**SUNDRY NOTICES AND REPORTS ON WELLS**  
*Do not use this form for proposals to drill or to re-enter an abandoned well. Use form 3160-3 (APD) for such proposals.*

8. Well Name and No.  
NEBU 602 COM 1H

9. API Well No.  
30-045-35775-00-X1

# NEBU 602-1H PILOT HOLE WBD

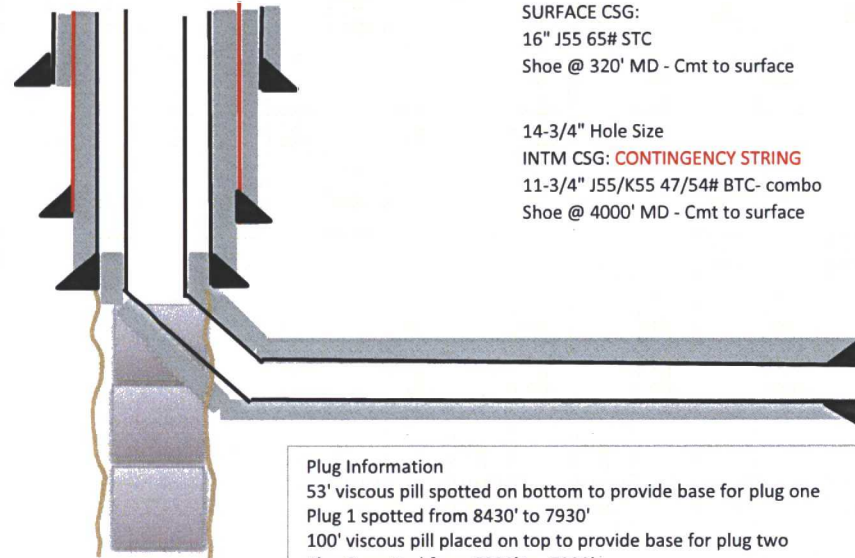
Please see the attached wellbore diagram noting the proposed plugs for the plug back of our pilot hole in the subject well.

Also please note by request of the NMOCD, the surface casing will be set at depth of 320'. **OIL CONS. DIV DIST. 3**

**Plug Information**  
53' viscous pill spotted on bottom to provide base for plug one  
Plug 1 spotted from 8430' to 7930'  
100' viscous pill placed on top to provide base for plug two  
Plug 2 spotted from 7830' to 7330'  
100' viscous pill placed on top to provide base for plug three  
Plug 3 spotted from 7230 to 6630'

**Pilot Coring:** After coring operations and open hole logging have been completed three cement plugs with viscous gel spacers will be pumped and the top of cement will be 6,630', approximately 200' above planned KOP(6,830' MD) for the lateral. Will utilize cement plugs to kick off from and drill the production interval.
